**PUBLIC LIBRARY  
700 E. Common Street  
New Braunfels, TX 78130**

## **ADA SELF-EVALUATION FACILITY SURVEY**

# New Braunfels Public Library

## #7 Priority 1: Accessible Routes

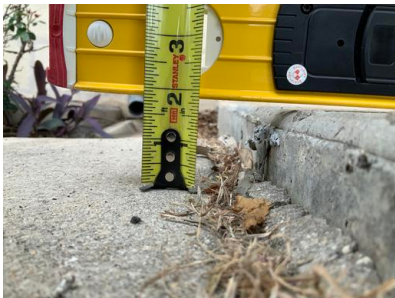
The sidewalk has a cross slope of to 4.6% and changes in level of up to 1-3/4" in two locations.

Recommendation: Remove and replace length of sidewalk. (4panels, 132 SF)

## #23 Priority 1: Accessible Routes

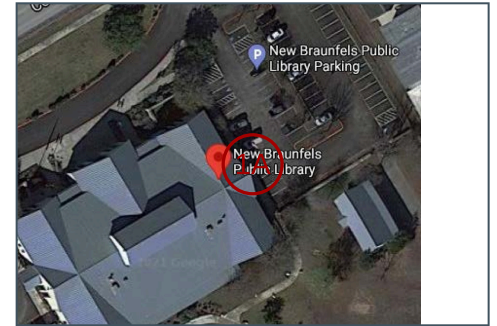
A portion of sidewalk leading to the reading garden has a cross slope of approximately 3.1%.

Recommendation: Remove and replace sidewalk. (One panel, 42 SF)

## #57 Priority 1: Accessible Routes

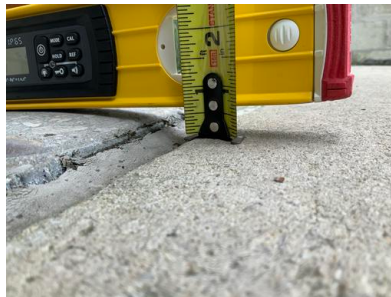
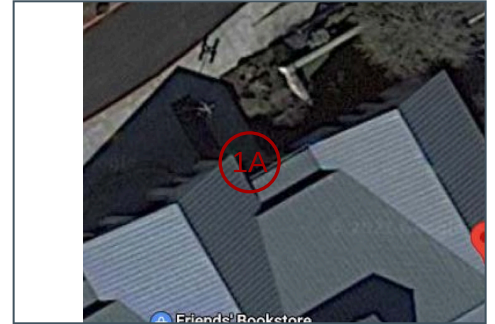
Route has an approximate 1/2" abrupt change in level at joint.

Recommendation: Grind edge to a maximum 1:2 bevel.

## #58 Priority 1: Accessible Routes

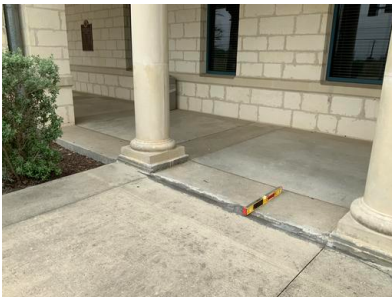
Route has an approximate 1/2" abrupt change in level at joint.

Recommendation: Grind edge to a maximum 1:2 bevel.

## #60 Priority 1: Accessible Routes

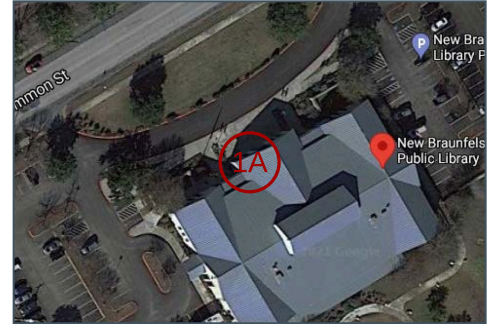
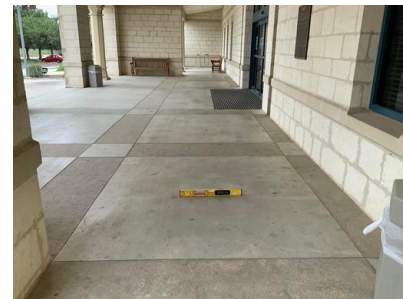
The covered approach to the main entrance has a cross slope of up to 2.7%.

Recommendation: Remove and replace sidewalk. (2 large panels, 160 SF)

## #10 Priority 1: Curb Ramps

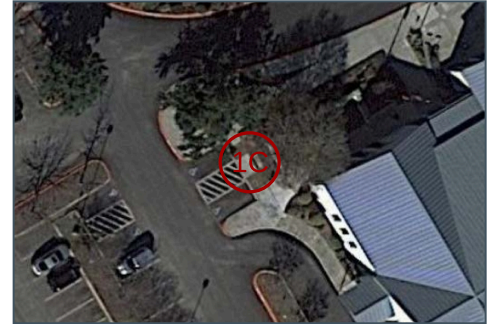
The landing and both runs of the parallel curb ramp have a cross slope ranging from 3.1% to 4.9%.

Recommendation: Remove and replace curb ramp.

## #14 Priority 1: Curb Ramps

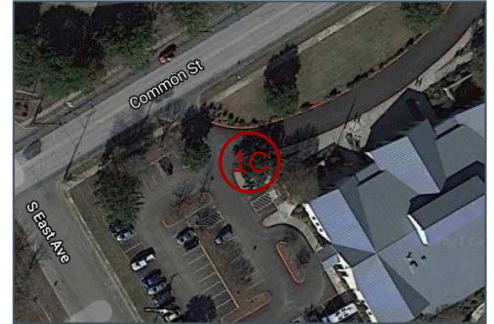
The parallel curb ramp at the west end of the circle drive has running slopes of 9 and 9.7% on each side.

Recommendation: Remove and replace curb ramp.

## #18 Priority 1: Curb Ramps

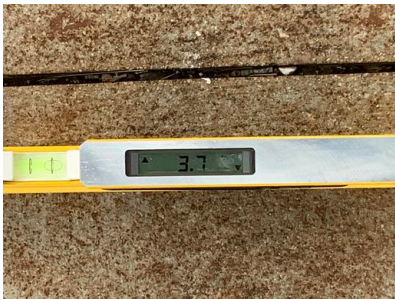
The parallel curb ramp at the east end of the circle drive has excessive cross slopes on both runs and the landing and excessive running slopes on the right-hand run.

Recommendation: Remove and replace curb ramp.

## #1 Priority 1: Parking

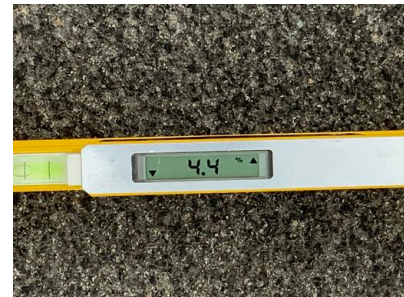
**Description**  
The three accessible spaces and access aisles facing the building have running slopes of 2.7% to 4.4%.

**Recommendation:** Replace asphalt surface.

## #4 Priority 1: Parking

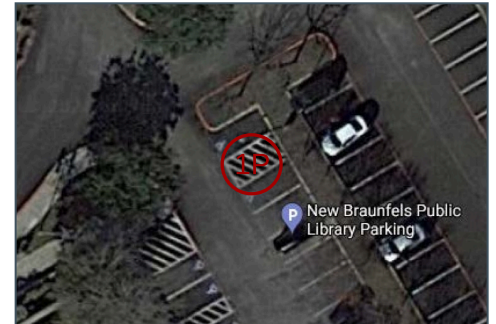
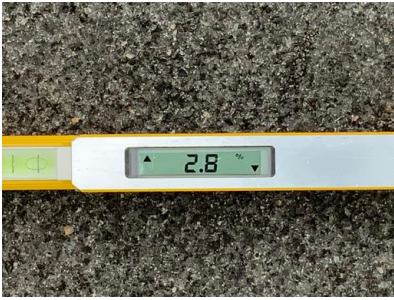
**Description**  
The two accessible spaces and access aisle across the drive have a running slope of 2.6% to 3.8%.

**Recommendation:** Replace asphalt surface.

## #62 Priority 1: Parking

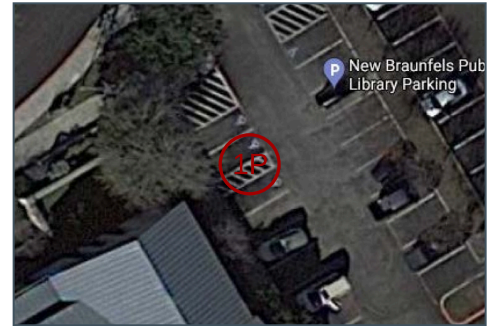
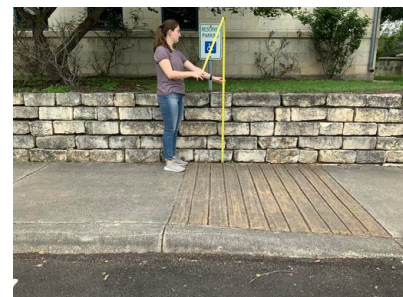
**Description**  
The vertical parking signs at the three spaces facing the building are mounted less than 60" to the bottom.

**Recommendation:**  
Reposition signs with the bottom at least 60" high.

## #20 Priority 1: Loading Zones

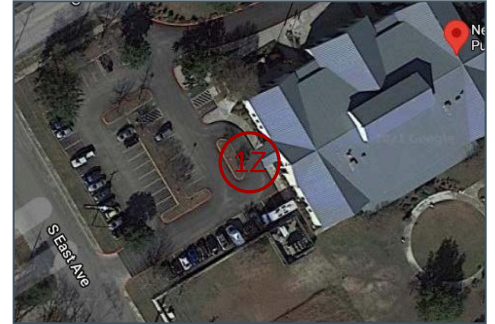
The covered vehicular area at the Book Drop has a cross slope of approximately 5.7%.

Recommendation: Remove and replace paving in this area to ensure a maximum slope of 2% in all directions. Stripe access aisle. (260 SF)

## #51 Priority 2: Accessible Routes

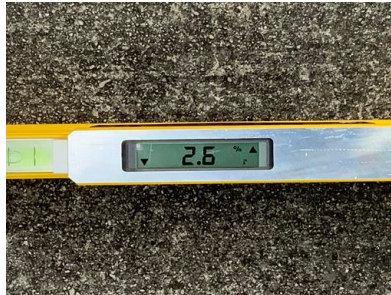
Sidewalk has a cross slope of up to 2.6%.

Recommendation: Remove and replace sidewalk. (1 panel, 72 SF)

## #52 Priority 2: Accessible Routes

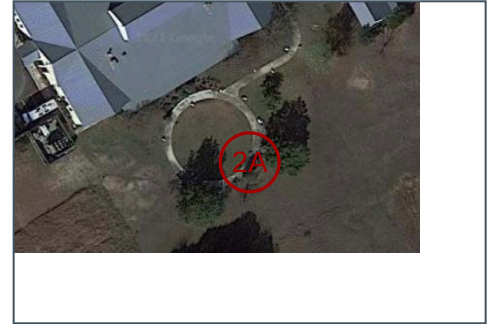
Sidewalk has a cross slope of up to 2.6%.

Recommendation: Remove and replace sidewalk. (1 panel, 72 SF)

## #36 Priority 2: Tables

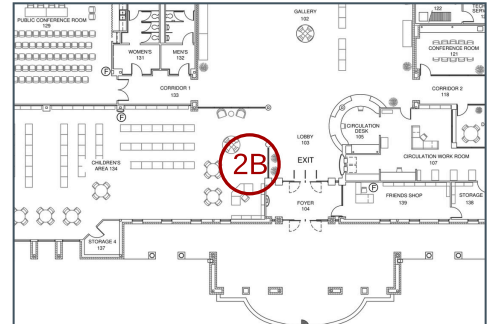
Description  
The computer tables are 24-3/4" high and have a knee space height of 23-1/4".

Recommendation: Install at least one computer station with a counter height of 26-30" and a knee space height of 24" minimum for children's use.

## #39 Priority 2: Tables

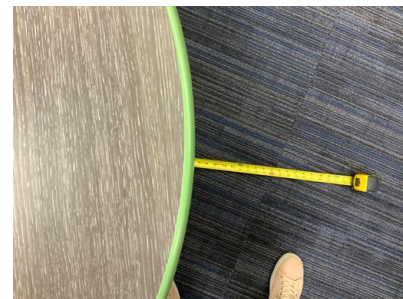
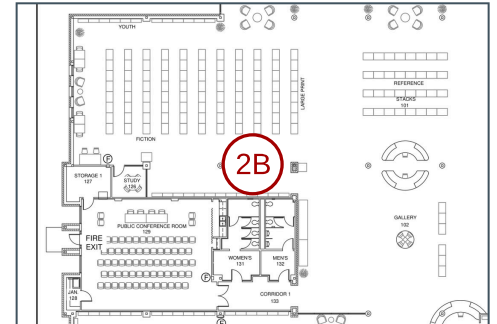
The round tables throughout the stacks area do not have accessible toe space depth below.

Recommendation: Install at least one accessible table.

#40 Priority 2: Tables

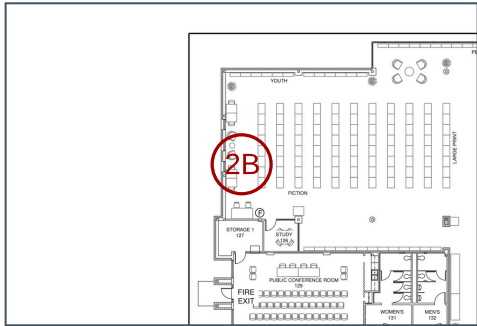
Description  
Booth tables do not have adequate toe clearance for a forward approach.

Recommendation: Install at least one accessible booth table.

## #41 Priority 2: Counters

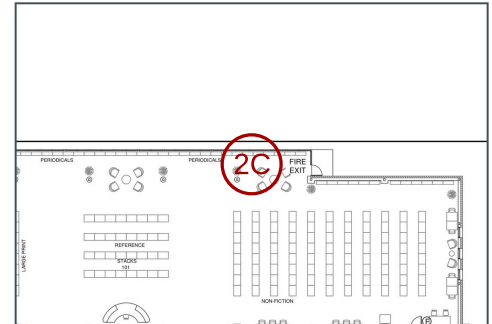
**Description**  
The charging station counter is 43" high.

Recommendation: Modify a portion of the counter to a maximum height of 34".

## #43 Priority 2: Counters

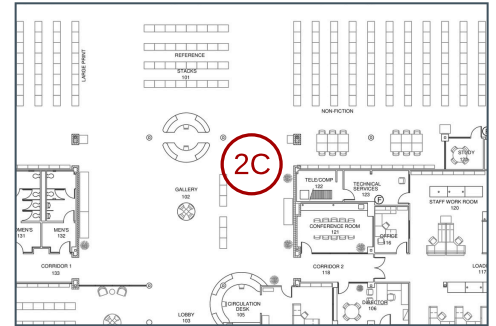
**Description**  
The catalog computers are located on a 41-1/2" high counter with no knee and toe space.

**Recommendation:** Relocate at least one computer to an accessible table.

#44 Priority 2: Counters

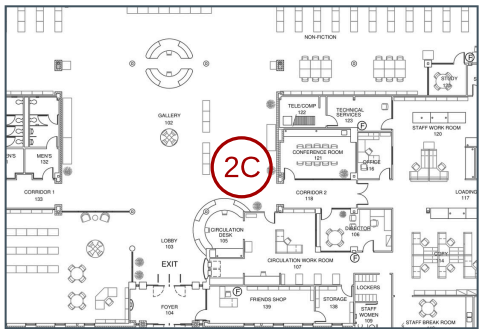
Description  
The self-serve library card sign-up station has a counter height of 38-1/2".

Recommendation: Lower the counter to 34" high maximum with compliant knee and toe space below.

## #38 Priority 2: Reach Range

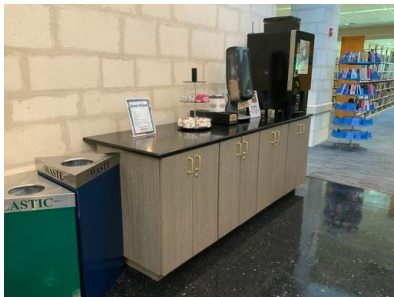
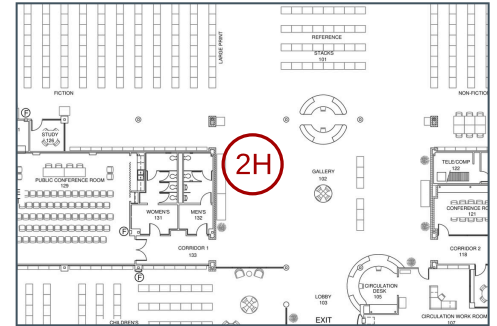
Description  
The coffee bar counter is 36" high.

Recommendation: Lower the counter to 34" high maximum to allow reach to self-serve elements.

## #26 Priority 3: Baby Changing Stations

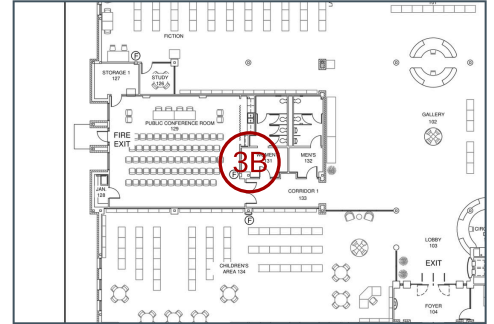
The baby changing table has a rim height of 37".

Recommendation: Modify the table to have a maximum height of 34".

## #35 Priority 3: Baby Changing Stations

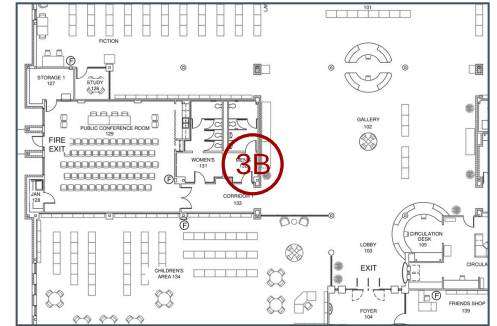
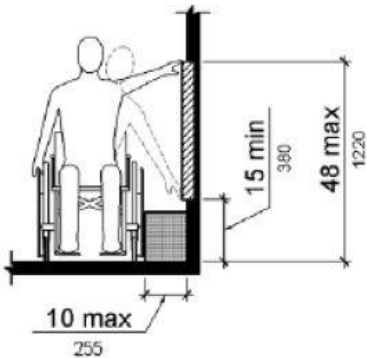
The baby changing table requires a reach of 52-1/2" to open and is located within the required maneuvering area of the door.

(Please note that TDLR considers baby changing stations to be protruding objects in their open position where the bottom of the table is more than 27" high. In this instance, the table obstructs the door maneuvering clearance in the open position.)

Recommendation: Relocate baby changing station outside of the door maneuvering area and position with the handle no higher than 48".

## #28 Priority 3: Toilet Compartments

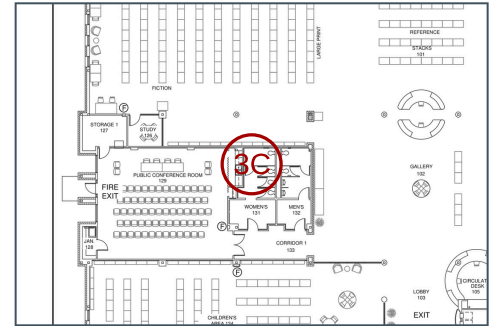
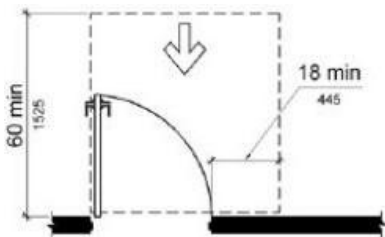
**Description**  
The door to the wheelchair accessible stall has only 6" of clearance past the latch on the pull side. And no door pull is installed on the inside of the stall door.

**Recommendation:** Swing door inward. Install door pull.

## #31 Priority 3: Toilet Compartments

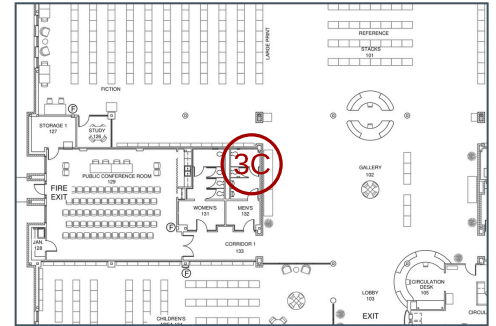
**Description**  
The door to the wheelchair accessible stall has only 6" of clearance past the latch on the pull side. No door pull is installed on the inside of the stall door, and the door is not self-closing.

**Recommendation:** Swing door inward. Install door pull. Adjust hinges.

## #30 Priority 3: Grab Bars

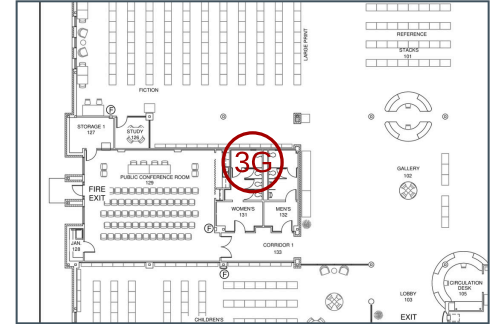
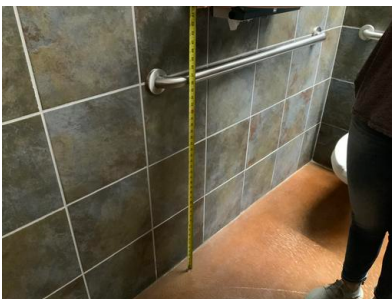
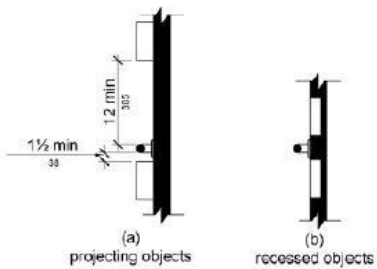
The grab bars are installed with the top of the gripping surface 36-3/4" high, and the side grab bar has only 6" of clearance above the bar.

Reposition grab bar with the top of the gripping surface 33" to 36" high. Relocate toilet paper dispenser below grab bar.

(Note: If these elements were installed prior to March 15, 2012, this condition may enjoy safe harbor until replaced.)

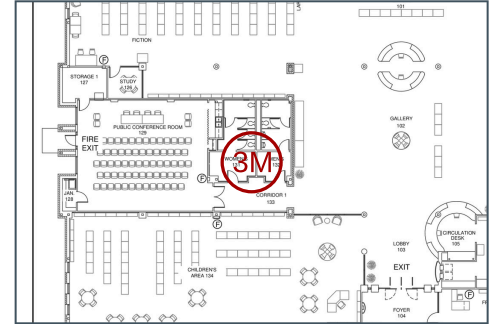
The mirror is mounted with the bottom of the reflective surface 48-1/2" high.

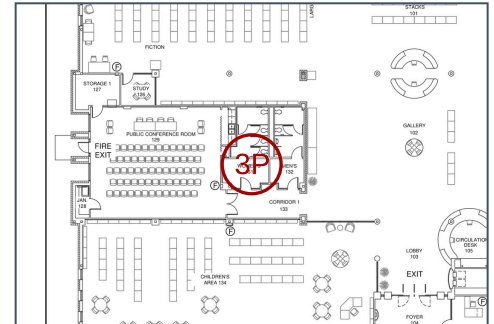
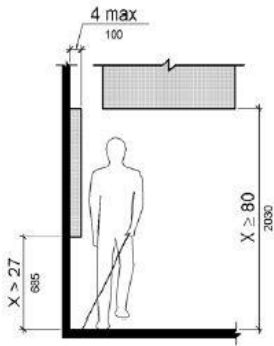
The hand dryer protrudes 6-1/2" at 39" high.

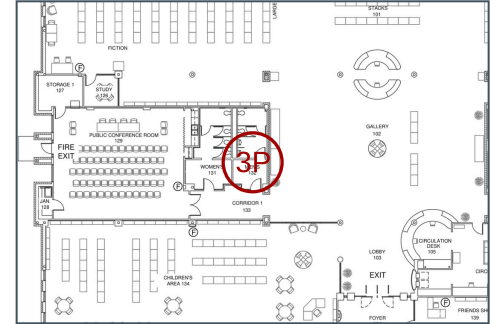
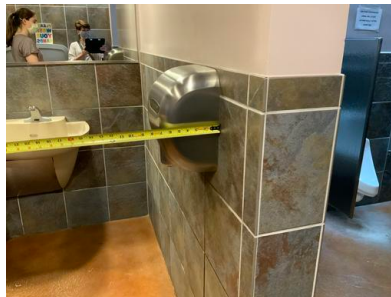
The hand dryer protrudes 6-1/2" at 39" high.

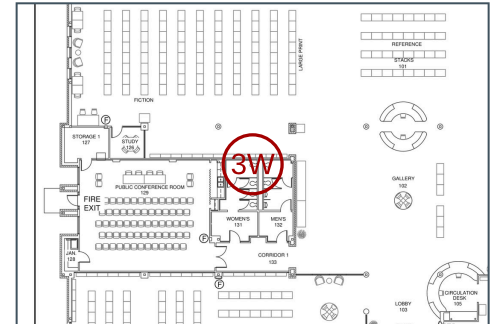
The centerline of the water closet is 18-1/2" from the side wall.

Reposition water closet with the centerline 16" to 18" from the wall.

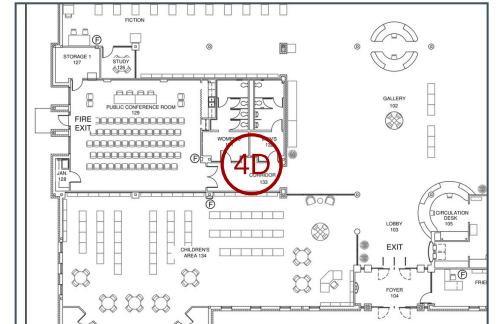
One accessible drinking fountain is provided, but no standing height fountain is provided.

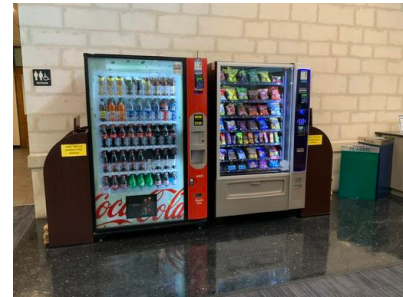
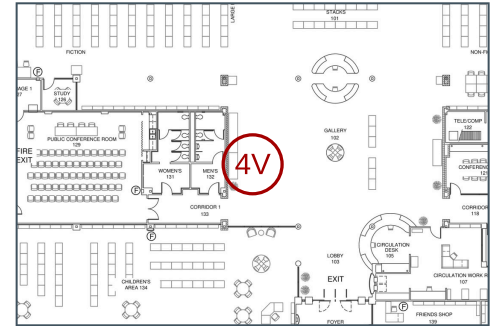
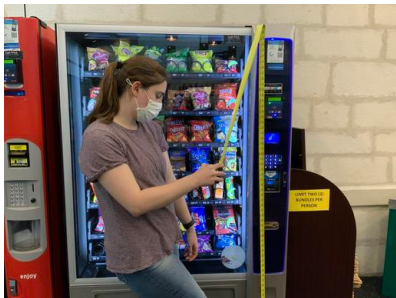
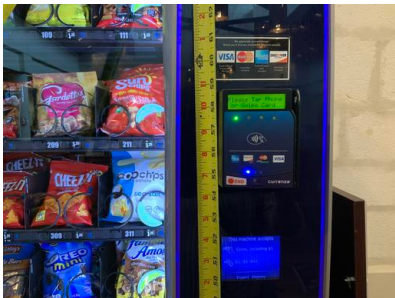
The vending machines have card swipes positioned 59" and 65" high.

Recommendation: Replace vending machines.
